Re: FortisBC Inc. (FBC)

**Application for Approval of a Certificate of Public Convenience and Necessity for
the A.S. Mawdsley Terminal Station Project (Application) ~ Project No. 1599424
Response to the Industrial Customers Group (ICG) Information Request (IR) No. 2**

LTC CONDITION ASSESSMENT REPORT ASM T1 and T2 TRANSFORMER

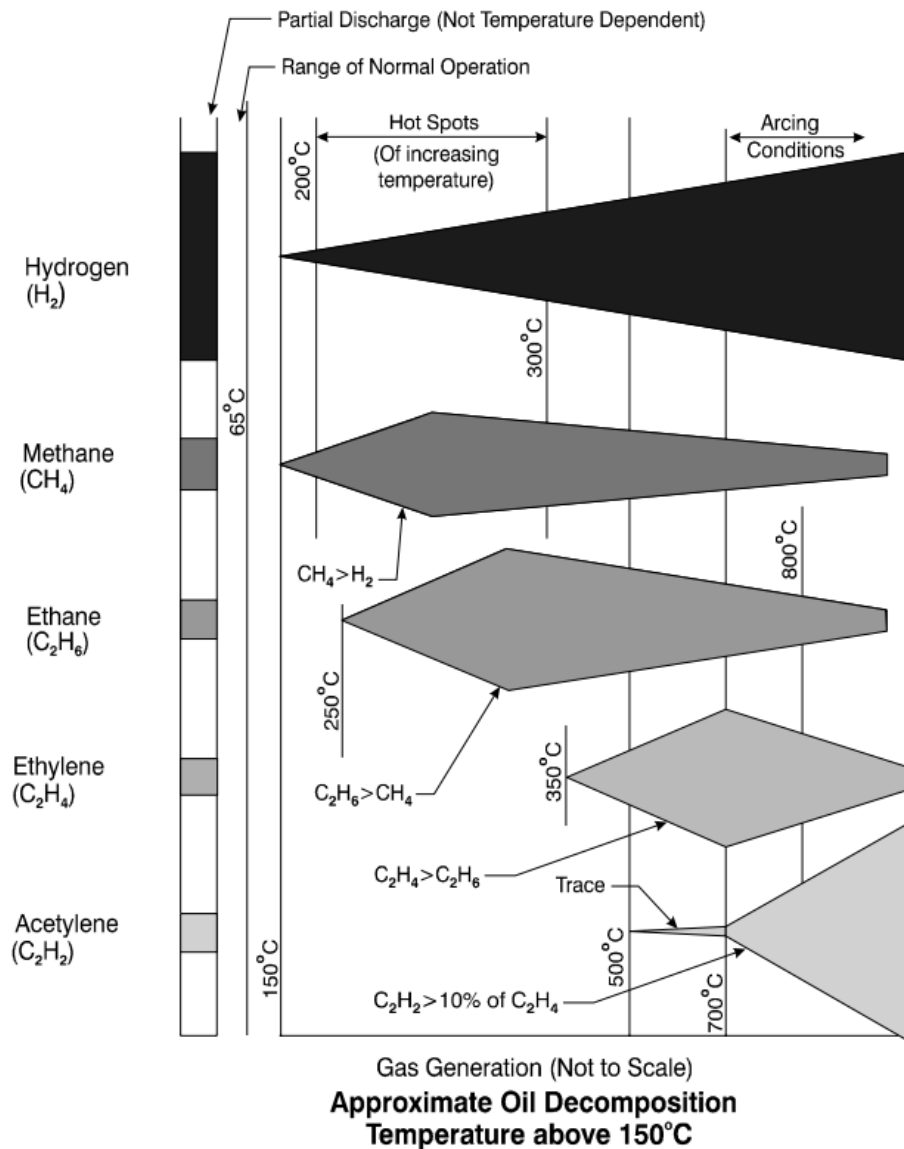
4 3.1 Arcing is an expected phenomenon for on-load tap changers. Please describe
5 whether the “violent arcing” in the reference is beyond what is normally expected
6 in on-load tap changer operation and provide the data that led to that conclusion.
7

9 Certain fault gases are produced more frequently in transformer oil as fault temperature
10 increases. Please refer to the figure below from the US Bureau of Reclamation brochure “FIST 3-
11 30 Transformer Maintenance” which indicates that acetylene is mainly produced during arcing.

Figure 3 ASM T1 High Carbon Contamination

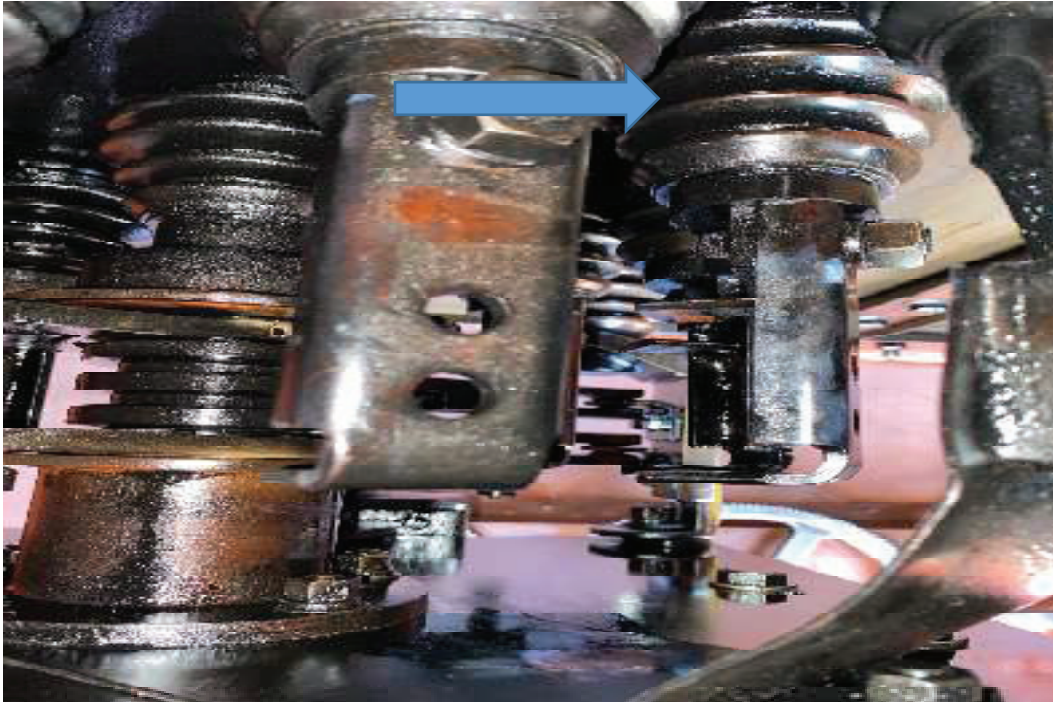
#	Assessed Component	Findings	Corrective Actions
1	Liquid Insulation Condition	Oil filtration pump was found not working. The insulating oil was heavily contaminated with carbon (see Figure 3).	The LTC tank was drained and refilled with new oil. The tank and components were properly cleaned. Oil filtration is currently working.
2	Solid Insulation Condition	Ceramic pass-through bushings were heavily contaminated with carbon deposits. The LTC insulating board had no cracks and there were no leaks.	Clean up was performed.
3	Mechanical Motion (1)	The following were inspected and found in acceptable condition: <ul style="list-style-type: none"> • Geneva gear and Geneva drive • Scroll cam • Levers • Assembly boards 	NA
	Mechanical Motion (2)	The LTC was operated without oil. It seemed to operate properly but noisy-violent. Dynamic Braking System could not be inspected (protective shroud could not be removed). No bouncing was observed but the mechanism did not stabilize immediately after the tap sequence was completed. This appears to be normal for unit with no dashpots.	NA

Figure 4 ASM T2 Coking of Selector Ring and Carbon Contamination

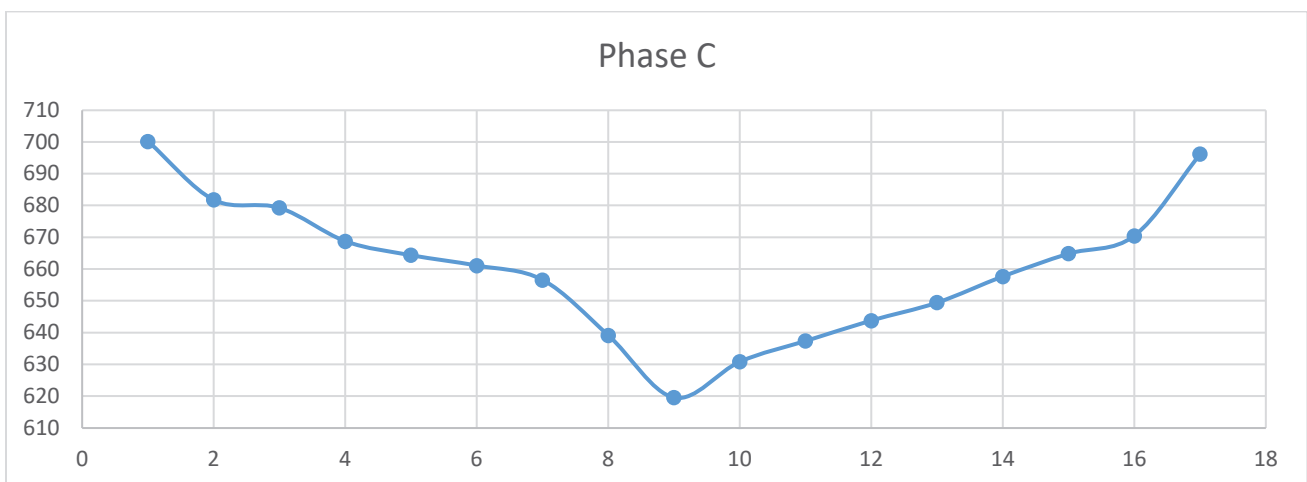
Rings and Push Rods	seem to be in good shape. There were no signs of flash over or across. There is no need for contact replacement.	
8	Reversing Switch and Contacts	The reversing switch seemed to operate properly. There were signs of pass-through operation (scratches). No coking was observed. There is no need for contact replacement.	NA
9	Diverter Contacts (1)	Diverter's main mobile and fixed contacts did not show signs of wear and did not need to be replaced.	<i>Review action plan after completing EIR-E-2023-09 "GLE T2 LR 83 LTC failure"</i>
	Diverter Contacts (2)	Diverter's arcing contacts were found heavily pitted. In-service contacts are reverse engineered after market parts and do not pair off properly (angled, not flat). This explains DGA results and the assumption of violent-uncontrolled arcing (see Figure 5)	Only cleaning was completed. In 2-3 years, all arcing contacts should be replaced.

Figure 6 ASM T2 Misalignment of the gear mechanism

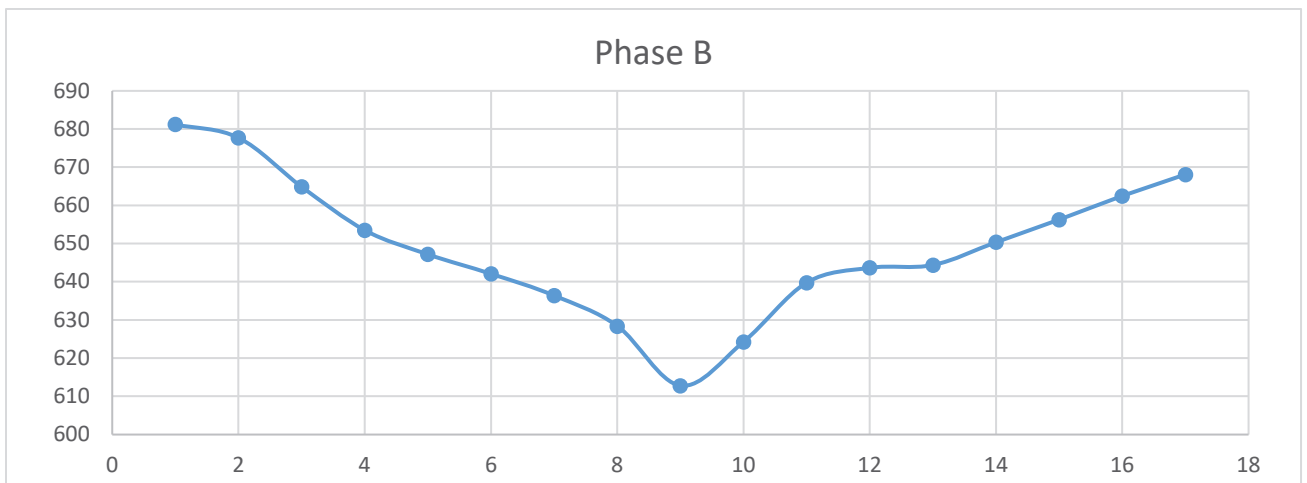
4	Synchronization	The three LTC heads seem to operate in perfect synchronism and the sequence of operation was as expected. A misalignment was observed in the operating gear and that might be caused by operating gear wear (see Figure 6).	Investigate further.
5	Critical Measurements	Due to the age of the compression springs, a jig saw pattern was recorded during electric resistance measurement (see Figure 7). This is a sign of non-uniform/reduced contact pressure.	User manual is not available. Measurements and adjustments could not be performed. Manually actuating each contact was the only option.
6	Tap and Stud Contacts	Based on visual inspection only, contacts seem to be in good shape and there is not need for immediate replacement. Some moderate contact coking was observed (see Figure 4).	Due to the lack of spare compression springs, dismantling was not attempted. Slide contacts were cleaned by operating the LTC.

Figure 7 ASM T2 Winding Resistance (LTC side)

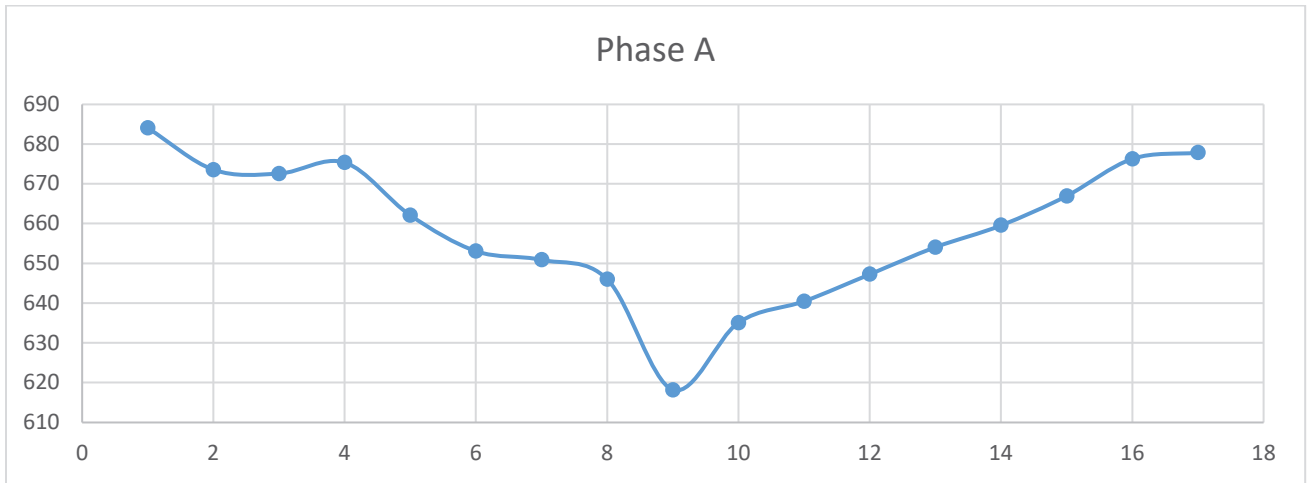
10	Auxiliary Contacts	The auxiliary contacts were visually inspected and are in ok condition.	Contacts were cleaned with spray on contact cleaner.
11	Motor Drive	Measured inrush and operating currents did not indicate any problems.	LTC motor is not making use of starting capacitors. The centrifugal switches could not be assessed.
12	Tap Counter	The tap counter seemed to operate properly.	NA
13	Dynamic Performance	Some anomalies have been recorded. See Figure 7 indicating fluctuating tap to tap resistance.	Reschedule testing for 2024.
